E3632A-04B**S E R V I C E N O T E**Supersedes:
E3632A-04A**E3632A DC Power Supply****Serial Numbers: MY51250037 to MY99999999****Metal Strap Kit for tightening loose bumper and for fitting rear lock link in side-by-side rack mounting****Parts Required:**

Figure 2: Top view 3mm gap observed on rear lock link for side-by-side rack mounting

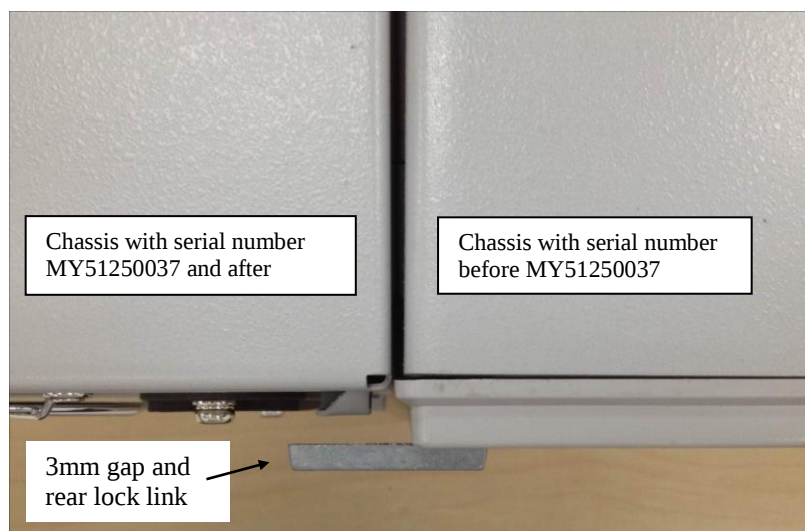
The 3 mm gap between the two different chassis may cause difficulties in securing them together using a rear lock link kit (part number 0050-2167) for side-by-side rack mounting as shown in Figure 2 below.

Solution for Situation 2

Use metal strap (part number E3631-07901), and stack the provided two metal straps together to form 3mm thickness and secure it with the provided screws on the rear lock link as shown in Figure 4 below.
